### **Submission in relation to application – RPI25/004 Arrow CASS tie-in**

LOCATION -Daandine Nandi Road, Ranges Bridge, Qld 4405. Approximately 25 km west of Dalby, Qld. (PAA Priority Agricultural Area) (SCA Strategic Cropping Area).

Figure D3 - Australian Land Use Management (ALUM) classification

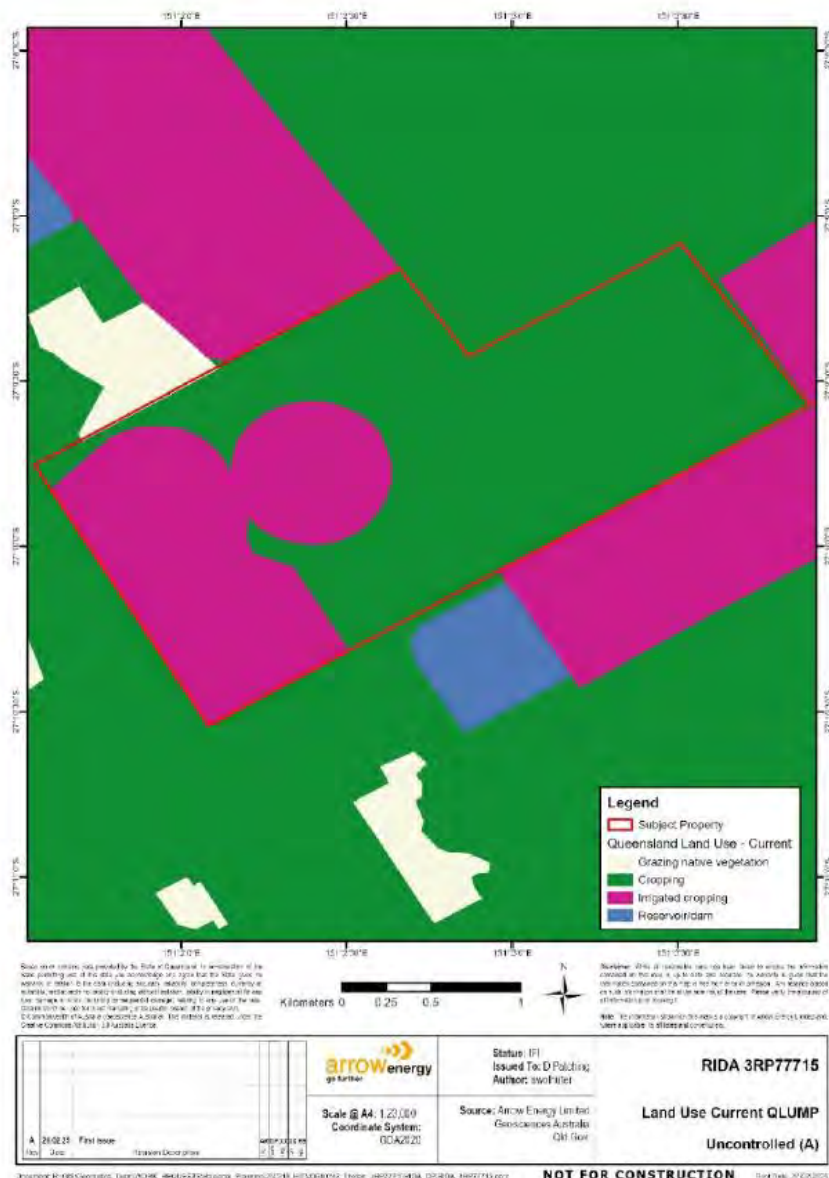
Some neighbouring properties to the south and east of the Subject land have established collection of overland flow water for use in irrigated cropping activities.

and unlike the legend indicates has grown cotton almost consistently year on year from 2014 to 2023. This could have easily been confirmed with some level of communication.

**Figure 3. OGIA model of predicted CSG subsidence by 2055.**

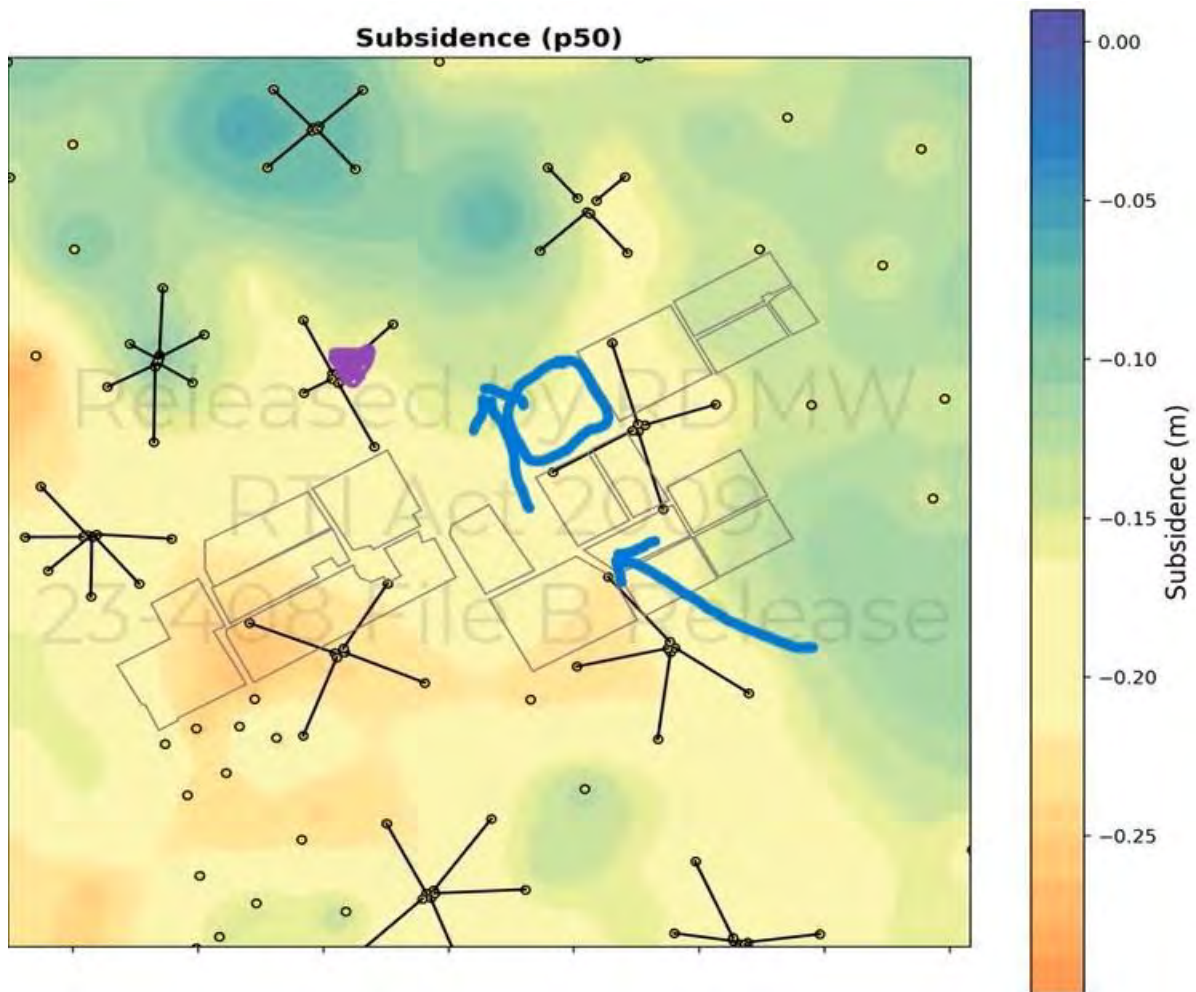
The risk of altering overland flow path is portrayed in this image. The path of water flow to the north is indicated to not subside significantly and most likely 0.05m.

The lower blue arrow is where the flood flow first enters [REDACTED] and is shown here to be likely to fall some 0.25-0.30 m. This is some 5-6 times the amount subsided in the direction of water flow. We now have the real possibility of flood water cutting back to the Wilkie Creek through the areas marked as orange. Water will always flow to the lowest point. If/when this eventuates, [REDACTED] lost some or a significant amount of water that [REDACTED] been able to harvest to enable [REDACTED] irrigation of intensive cropping on PAA.

Likewise, the area of the proposed tie-in valve and pipework is predicted to fall 0.20m whilst the path the water should be taking does not fall. The water may well divert through the region the subject of this RIDA.

Figure 4. OGIA LiDAR tool section near Tie-in valve.

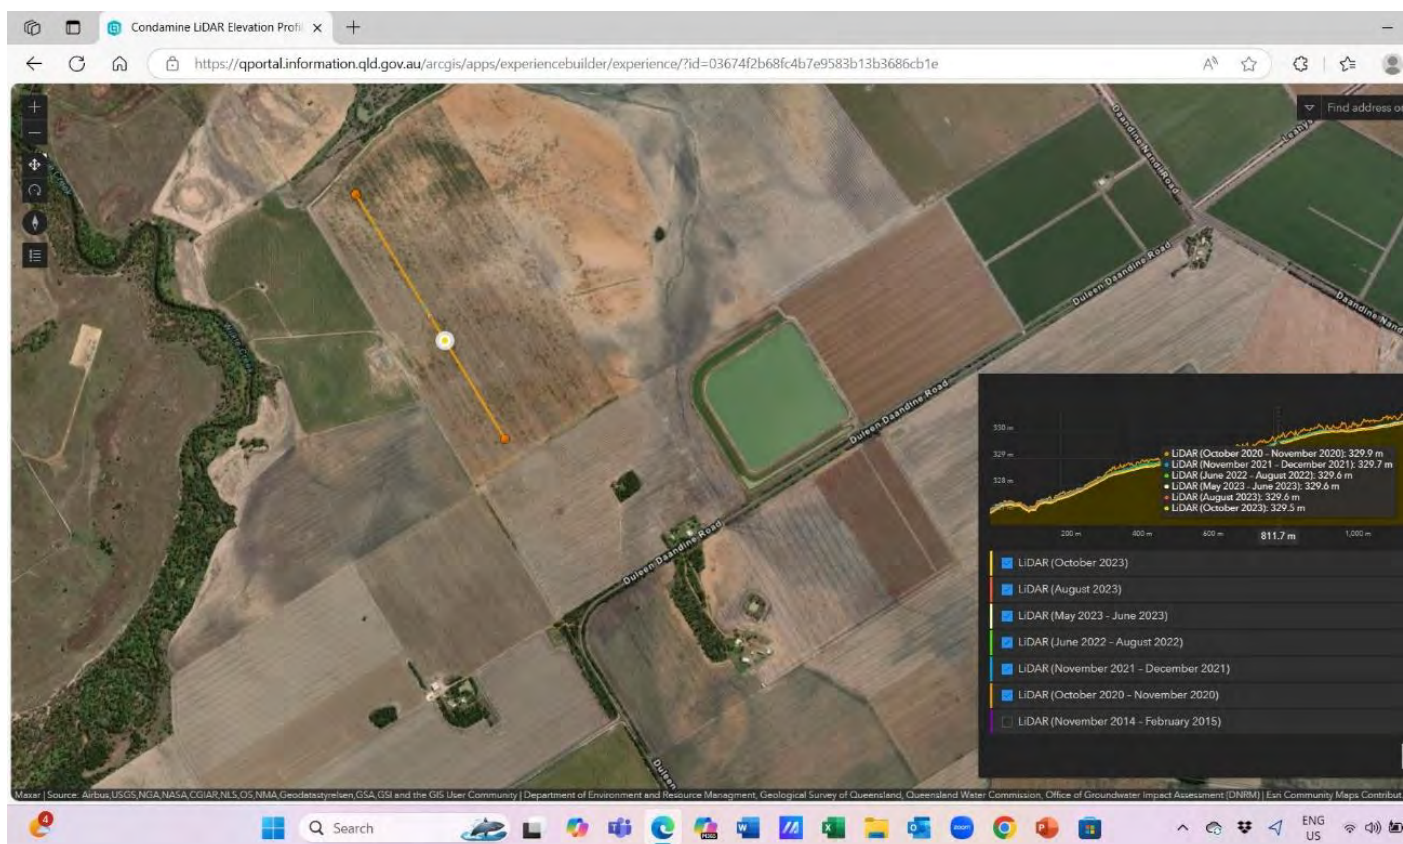
The OGIA LiDAR tool available online clearly shows the above area in the vicinity of the tie-in valve to have already subsided 0.4m (400mm). This is twice that predicted by the OGIA model and has occurred over some 3 years and not the 30 years predicted by the model.

Given that Figure 4 in relation to the OGIA LiDAR tool is showing 400mm (329.9m to 329.5m) of subsidence over a short time frame from Oct 2020 to Oct 2023, land levelling involving land planning would be required to the region in order to re-instate the land to the original PALU following construction activities.

**Figure 5. RPI25/004 Appendix J.**

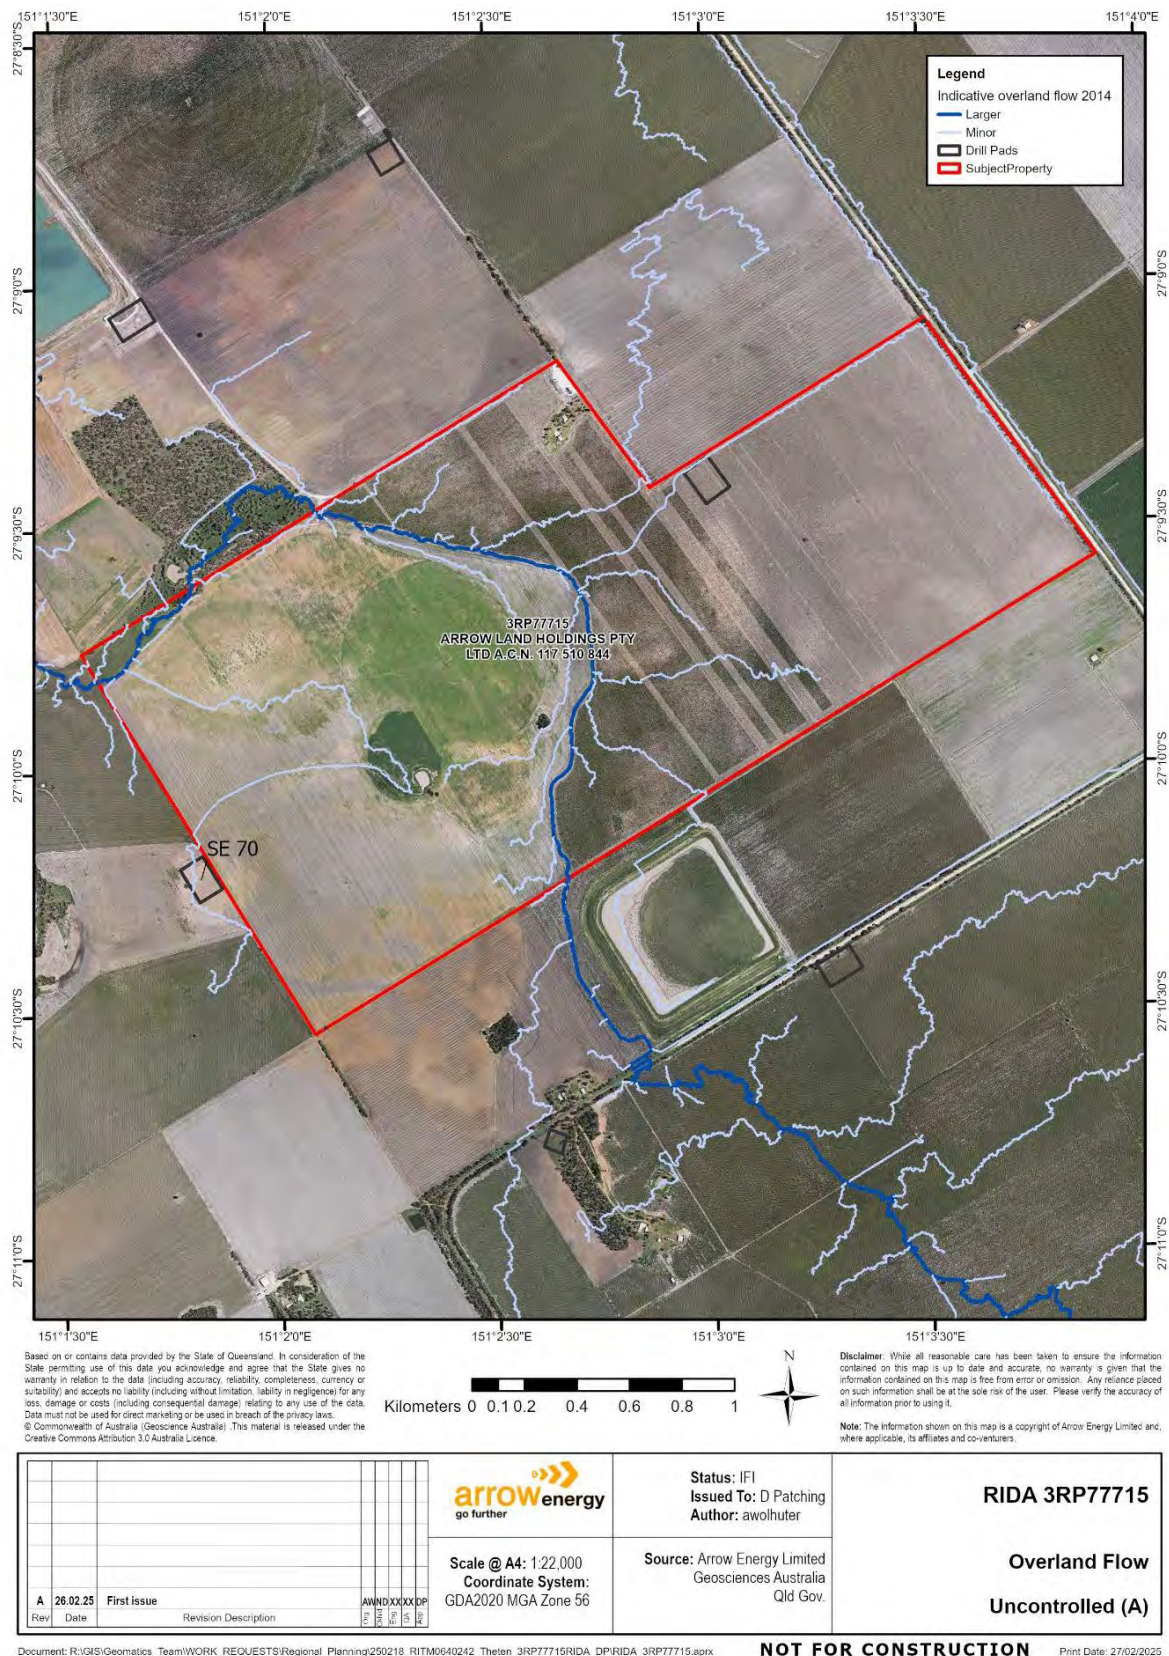
Arrow Energy have submitted the above Appendix J as part of the RIDA. The above representation shows that with CSG subsidence of the level now being experienced, the likelihood of change to water path away from present blue mainstream is real.
